Hop Lun Apparel Ltd. (Unit-2)

9 June, 2016

Client Summary report

High stress in columns

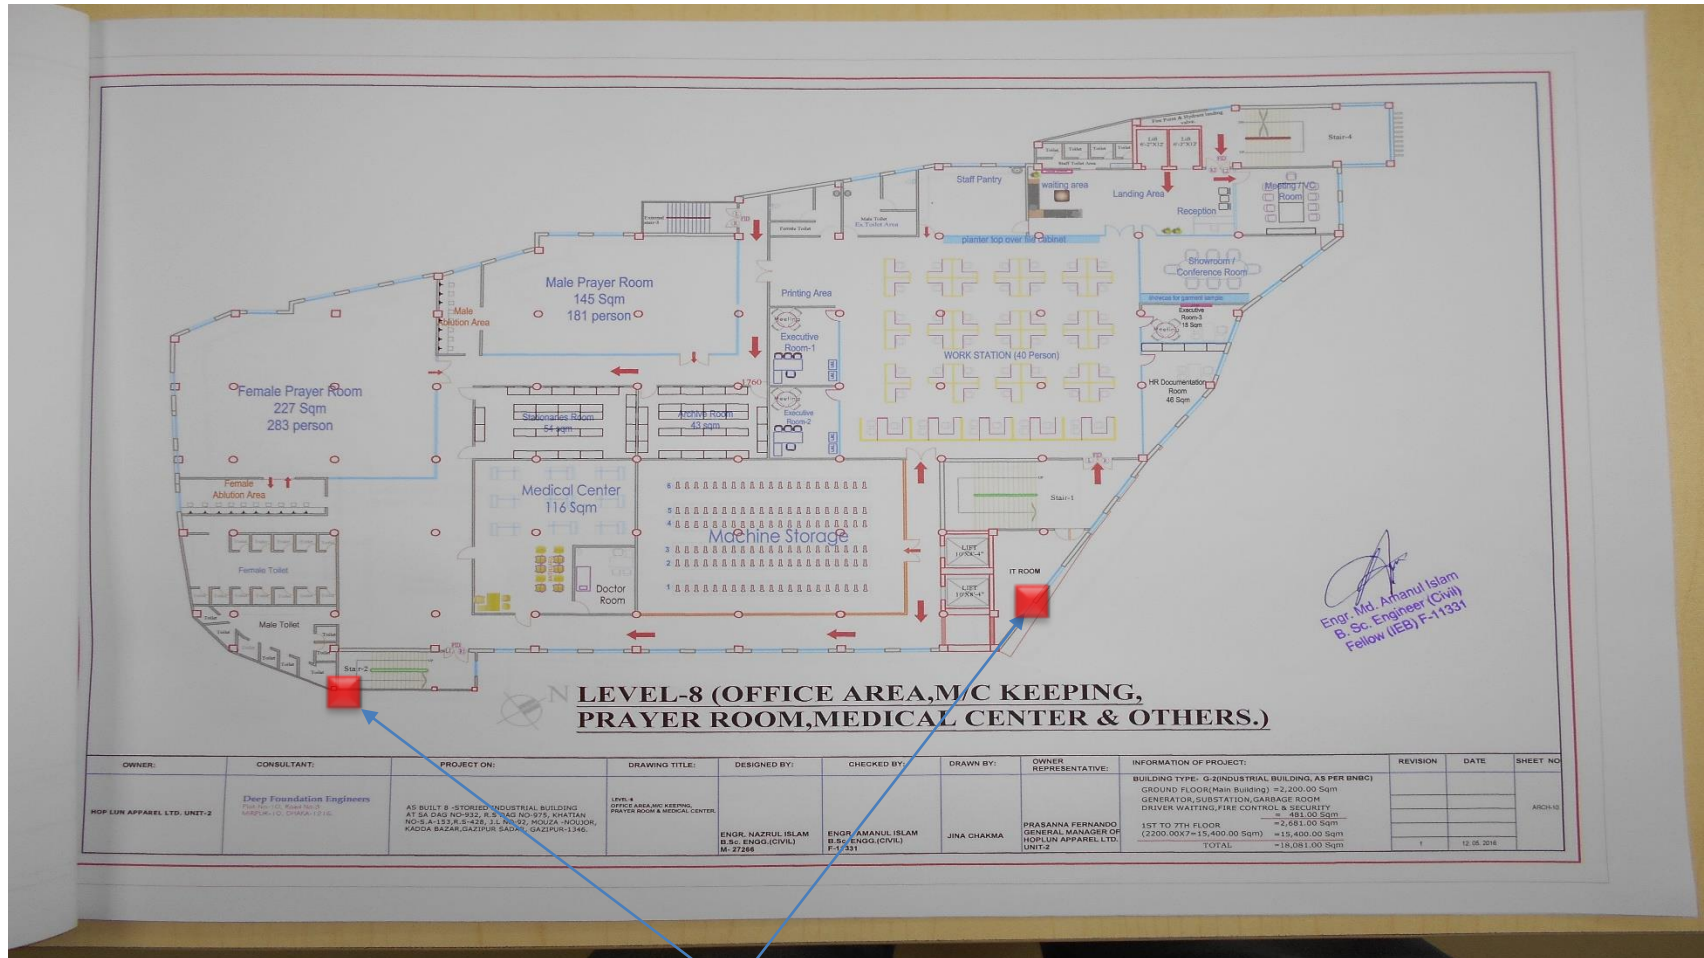
Cursory calculation indicates that identified column stress exceeds allowable limit.

Offset column above mezzanine floor.

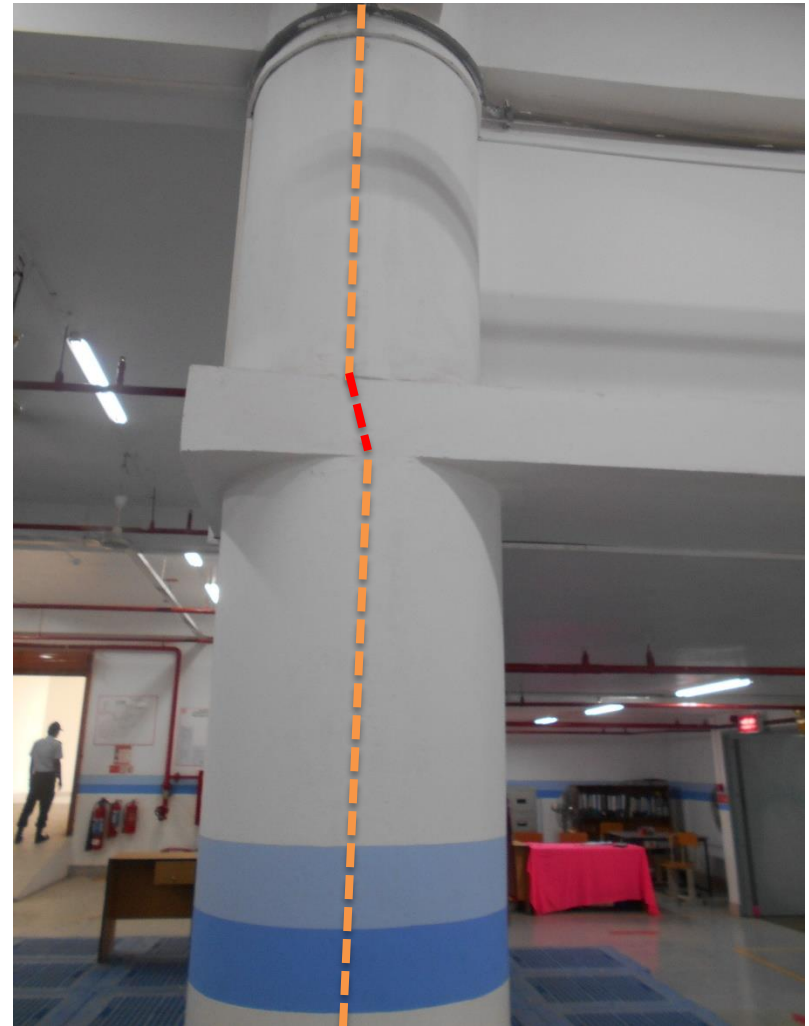
Columns above mezzanine floor were found offset from the ground floor columns. Column adequacy check is required for the eccentric load path.

Inconsistencies between existing drawings and As built condition

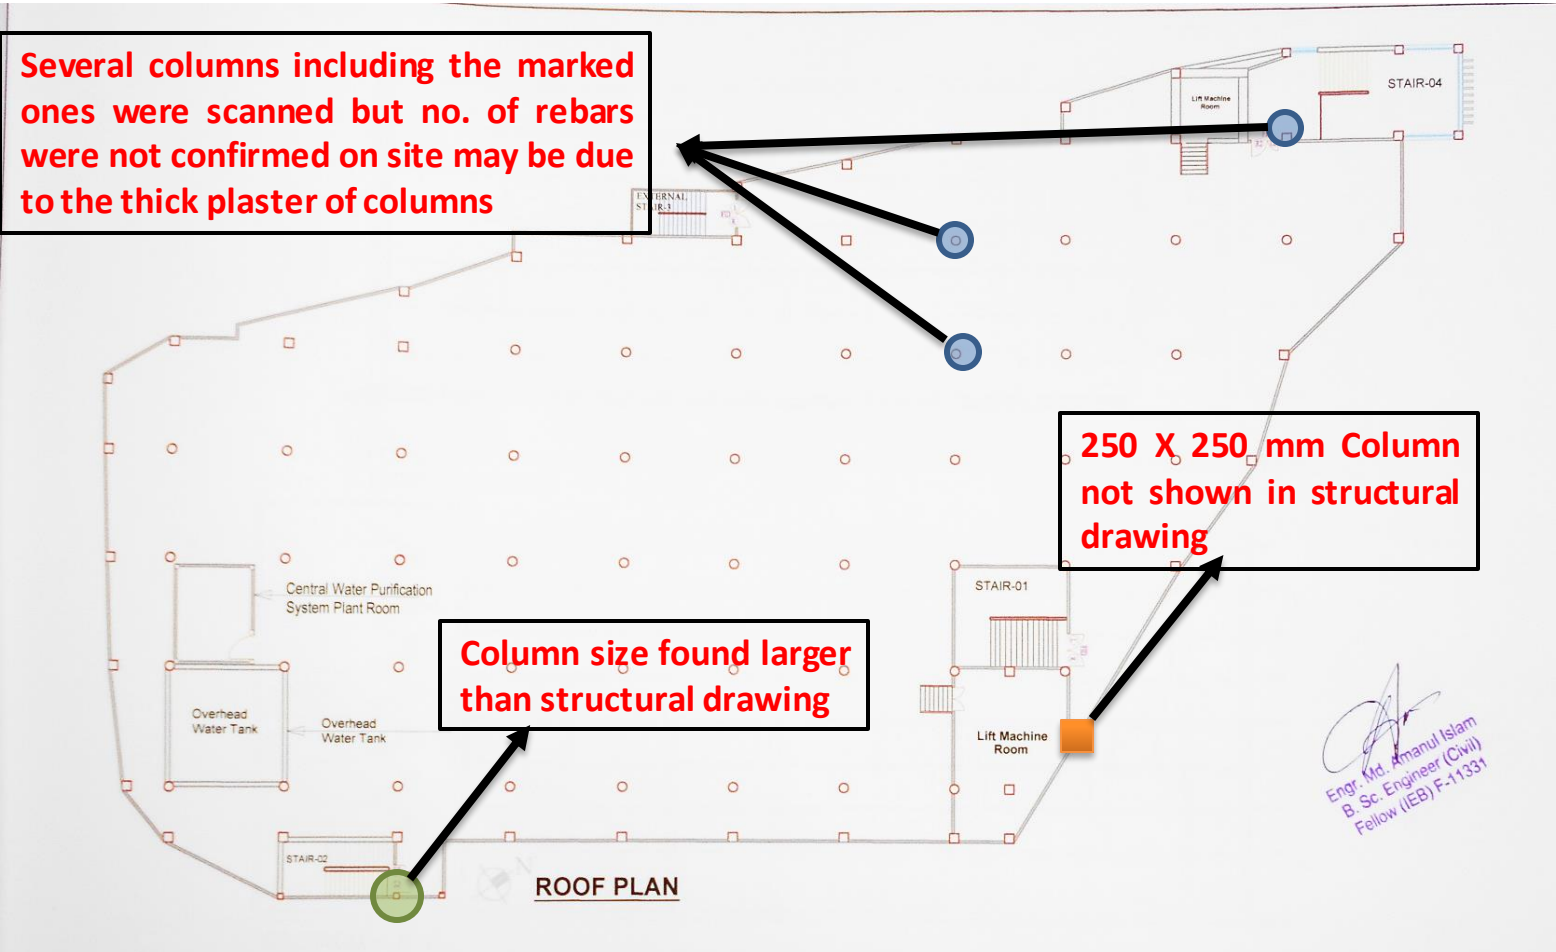
Several columns including the marked ones were scanned but no. of rebars were not confirmed on site may be due to the thick plaster of columns

250 X 250 mm Column not shown in structural drawing

Column size found larger than structural drawing
